ADDENDUM NUMBER 1

GMIA – Gates D54 & D55 Improvements

Project Number: A193-15000

Date of Addendum: June 16, 2015

1 NEW WORK PLAN - LEVEL 02 - POWER AND SYSTEMS
1/8" = 1'-0"

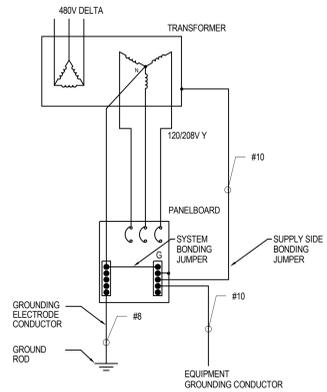
14. Sheet E210.

Add: In concourse area add symbols for existing ceiling mounted paging speakers on New Work Plan – Level 02 – Power and Systems. See revised sheet E210 included with this addendum.

Add: In the concourse area add symbols for ceiling mounted paging system ambient sound sensors on New Work Plan – Level 02 – Power and Systems. See revised sheet E210 included with this addendum.

Delete: References to keyed sheet notes 6, 7, 8, 9, 10, 11, and 12 from New Work Plan – Level 02 – Power and Systems.

Add: In concourse area add notation for gate stands at gates D54 and D55 on New Work Plan – level 02 – Power and Systems. At each gate stand add symbols for a duplex outlet, a data outlet, and a slave microphone station. See revised sheet E210 included with this addendum.

Revise: In concourse area at each gate podium revise microphone symbol to be a master station on New Work Plan – Level 02 – Power and Systems. See revised sheet E210 included with this addendum.

Revise: In concourse area at each monitor display revise quantity of data jacks to be one on lieu of two on New Work Plan – Level 02 – Power and Systems.

Revise: In concourse area at each gate podium revise number of jacks at podium to be 2D/2V and 2D only (in lieu of 2D/2V at the second location) on New Work Plan – Level 02 – Power and Systems.

Add: At each gate D54 and D55 add 1D data connection referenced to Keyed Sheet Note 2 on New Work Plan – Level 02 – Power and Systems.

Revise: Note #3, revise referenced room to be D145 in lieu of D119 on General Notes.

Revise: Revise Note #2 to read as follows,
“For jet bridge communications handset. Filed verify termination requirements to match existing jet bridges being relocated.” on Keyed Notes This Sheet.

Delete: Delete notes 6, 7, 8, 9, 10, 11, and 12 from Keyed Notes This Sheet.

Add: at the concourse area add a sheet note to read as follows,
“Existing gate podium in this area being removed by others. EC shall de-energize, disconnect, and remove existing 120 volt power circuit and voice/data cables to allow podium removal.” on New Work Plan – Level 02 – Power and Systems.

2 PAGING SYSTEM PARTIAL WIRING DIAGRAM
NTS

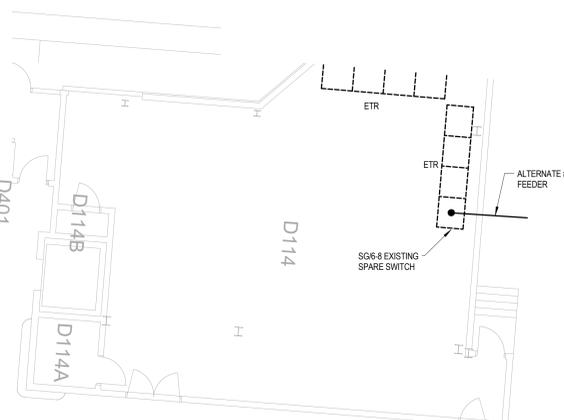
15. Sheet E401.

Add: Add diagram 2, Paging System Partial Wiring Diagram to Sheet E401. See revised sheet E401 included with this addendum.

PROJECT NO.: A193-15000	DATE: 06/16/15	BY: LAC	PROJECT MGR.: RJJ	SCALE: 1/8" = 1'-0"	REF. SHEET: E110
GRÄEF	PROJECT NAME: GMIA GATES D54 & D55 IMPROVEMENTS				SHEET
	SHEET TITLE: LEVEL 01 LIGHTING AND POWER REVISIONS				SK-2

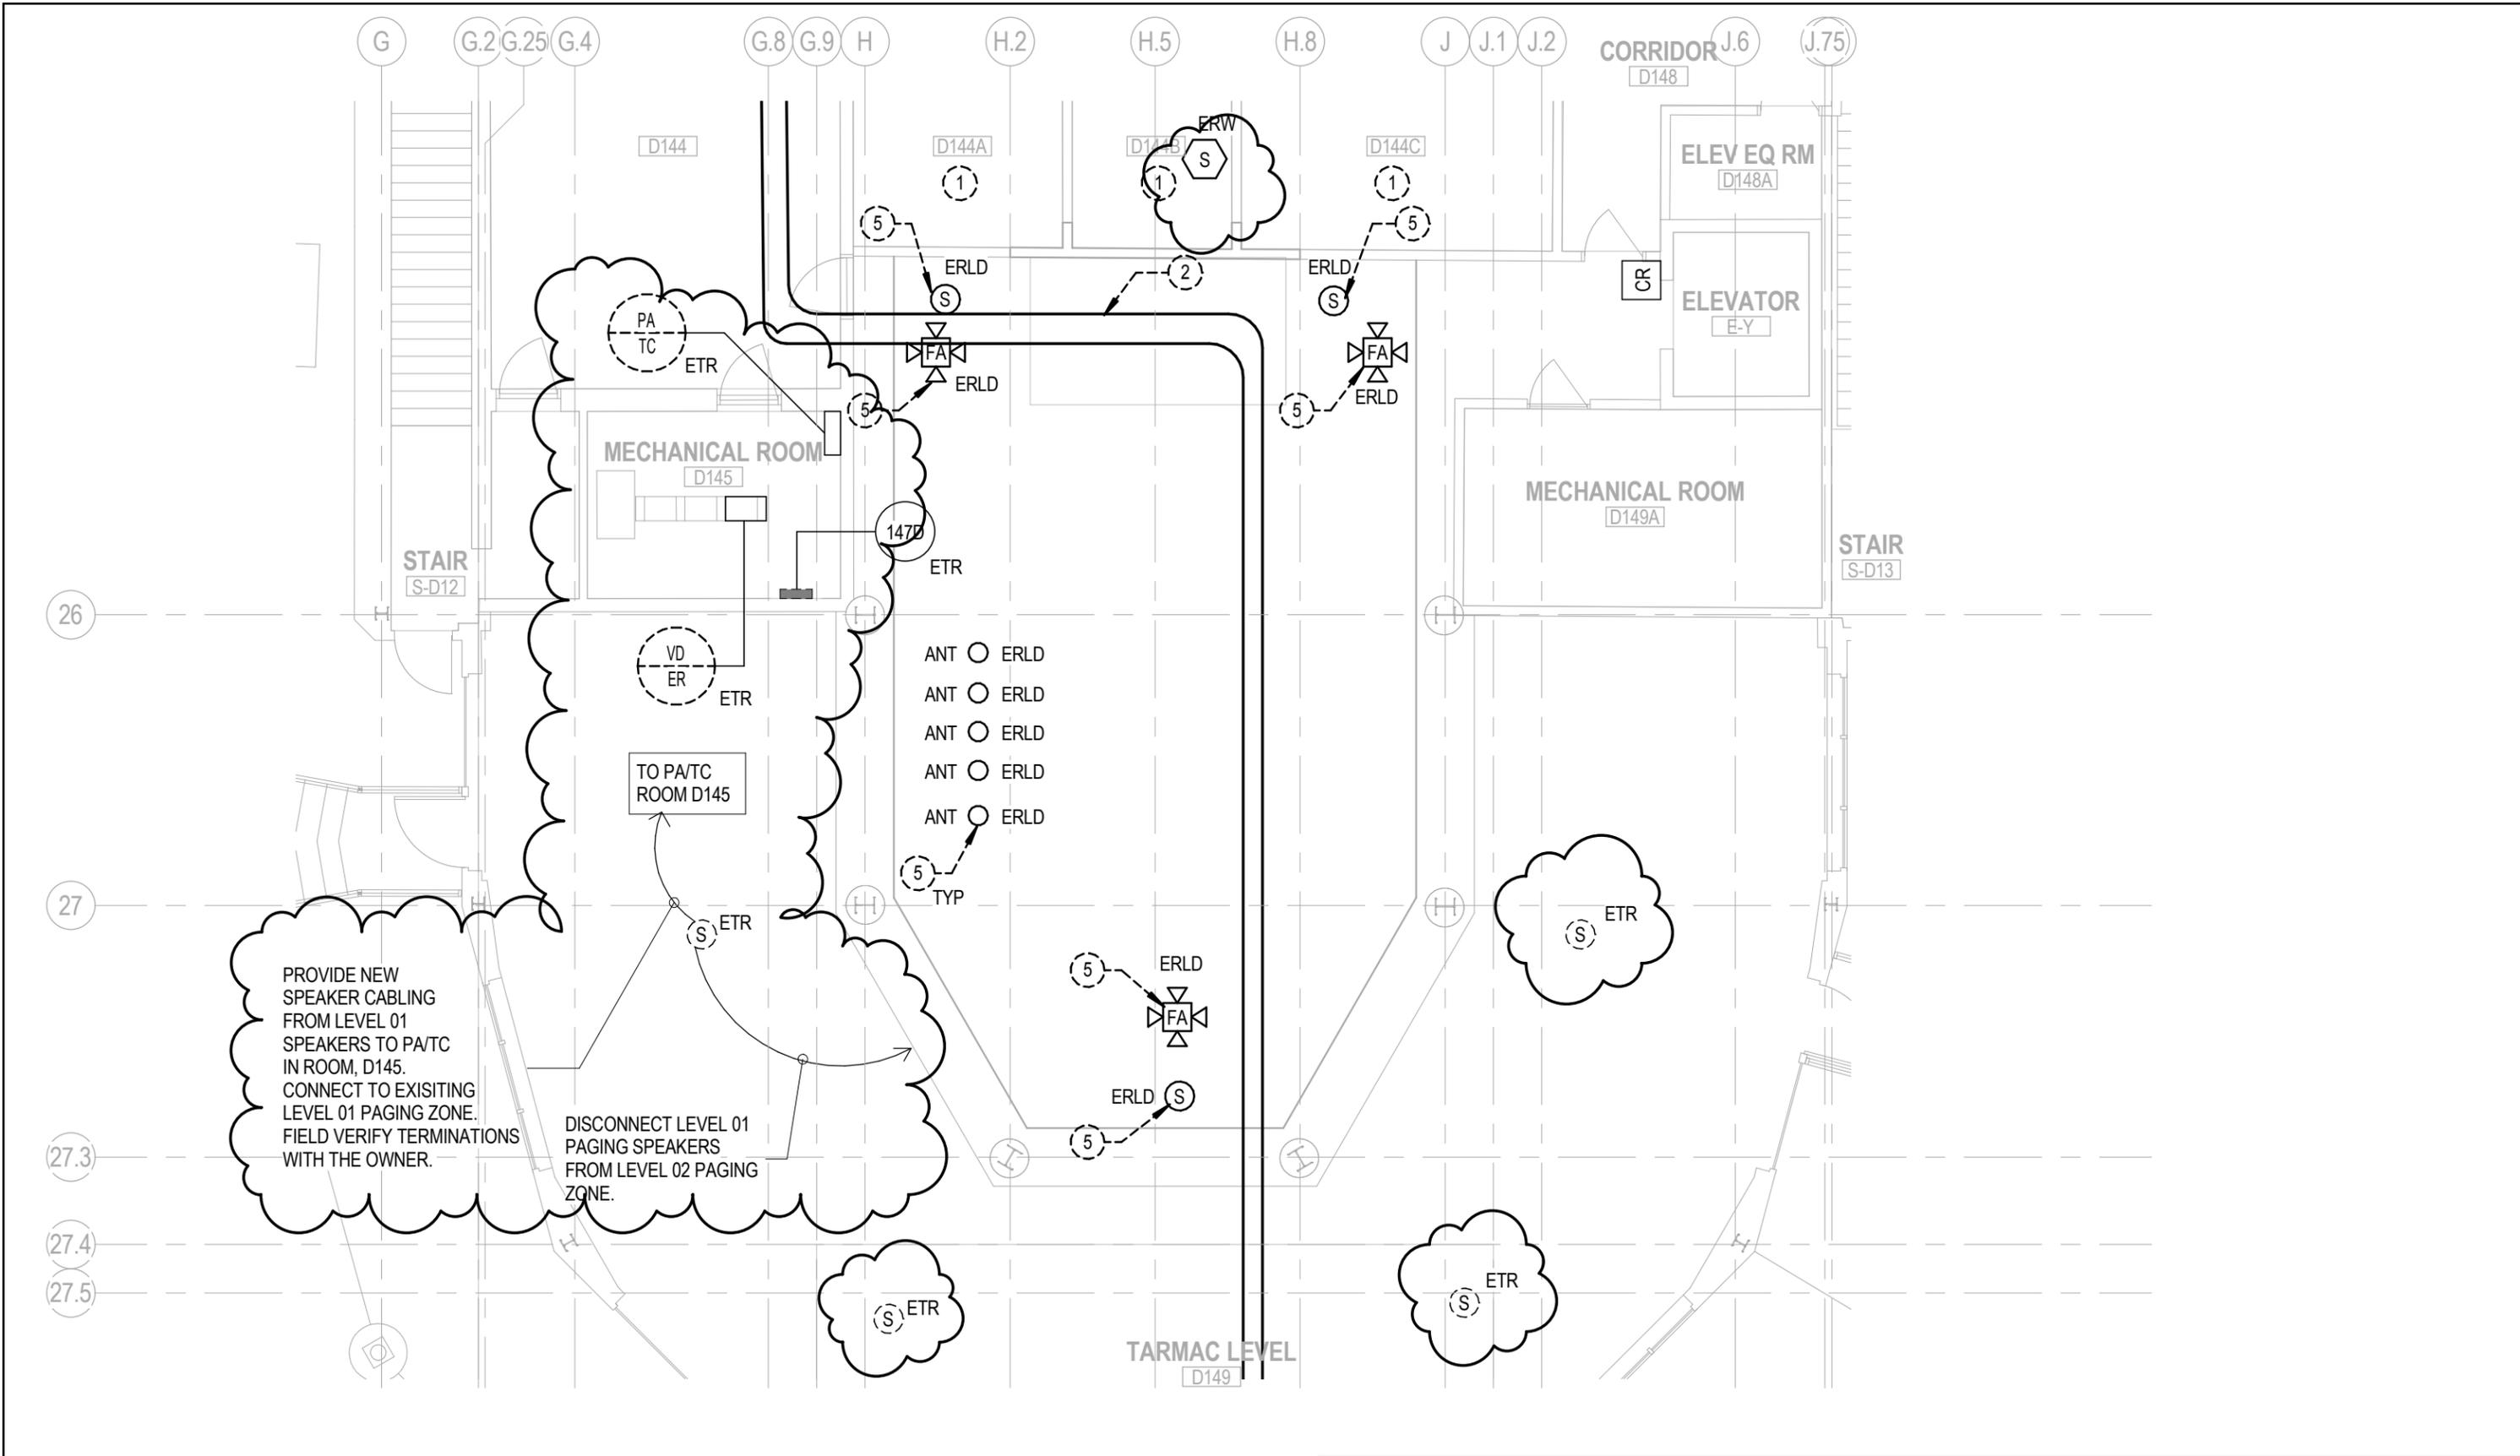
Add: Symbols for existing ceiling speakers in room D149 on New Work Plan – Level 01 – Power and Systems. Add associated notes to rewire existing speakers. See partial plan included with this addendum.

PROVIDE NEW SPEAKER CABLING FROM LEVEL 01 SPEAKERS TO PA/TC IN ROOM, D145. CONNECT TO EXISTING LEVEL 01 PAGING ZONE. FIELD VERIFY TERMINATIONS WITH THE OWNER.

DISCONNECT LEVEL 01 PAGING SPEAKERS FROM LEVEL 02 PAGING ZONE.
